Urgent Field Safety Notice
Product Correction
 Urgent - Immediate Action Required

Date Issued September 16, 2019

Abbott has identified a potential reliability issue with the Alinity ci-series Level Sensor, Bulk Solution (LN 04S68-02). The details of the issue and the potential impact is described below.

Figure 1. Examples of cracked level sensor (Not Acceptable)

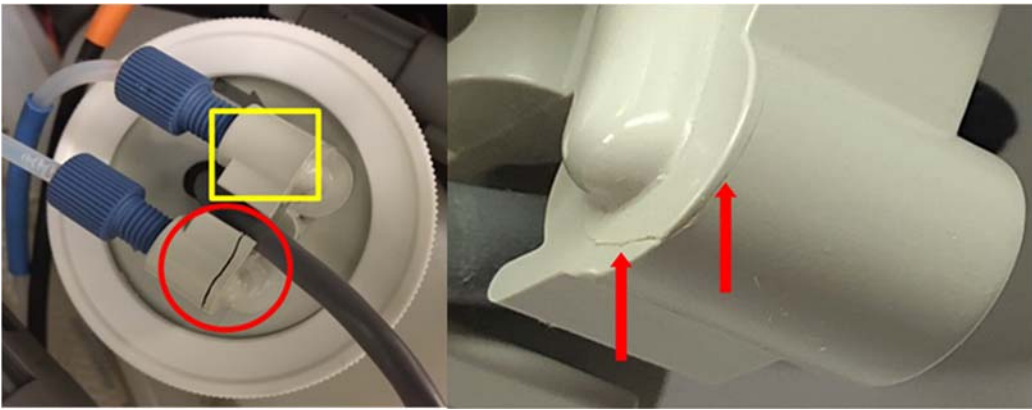
3. Inspect the inlet and outlet ports of each level sensor for cracks.

- Crack size and location on inlet and outlet ports is variable. See Figure 1.
 - On each level sensor, there is a “knit” line that is a normal outcome from the manufacturing process. The “knit” line is not a crack or defect in the level sensor. See Figure 2.
4. If crack(s) are detected,
 - Replace the bulk level sensor. LN 04S68-02 may be used until LN 04S68-03 is available. For replacement instructions, refer to the Alinity ci-series Operations Manual, Section 9.
 - Review results generated from the last successful quality control.
 5. When the inspection is complete slide the reservoir bottle tray into the bulk solution reservoir area and close the bulk solution door.

- Area in red circle indicates level sensor crack.
- Area in yellow square indicates undamaged port.
- Area with red arrows indicates cracks.

Figure 3. Identification of the Level Sensor, Bulk Solution (LNs 04S68-02 and 04S68-03)

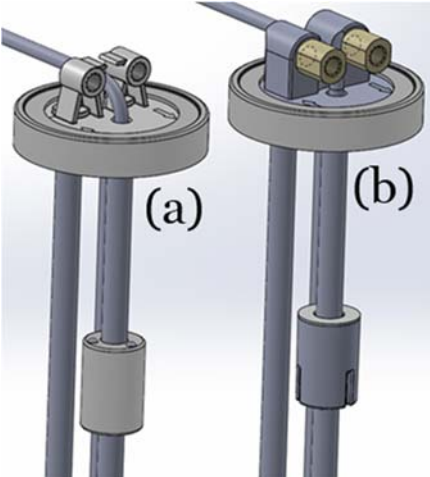
Abbott has redesigned Level Sensor, Bulk Solution (LN 04S68-02) to improve reliability. The redesigned Level Sensor, Bulk Solution (LN 04S68-03) will be available beginning in the fourth quarter of 2019. You may continue to run the system using part number (LN 04S68-02) until the replacement parts (LN 04S68-03) are obtained by taking the recommended actions outlined in this letter. Once the redesigned Level Sensor, Bulk Solution (LN 04S68-03) is available, Abbott recommends the replacement of the LN 04S68-02 in all positions on the Alinity c and i systems.

The development of environmental stress on the bulk solution level sensor can cause cracks. Cracks can allow air to enter the fluid line, which may result either a failure to dispense or an incomplete dispense of the bulk solution on Alinity i and Alinity c.

(a) Level Sensor, Bulk Solution LN 04S68-02, (b) Level Sensor, Bulk Solution LN 04S68-03
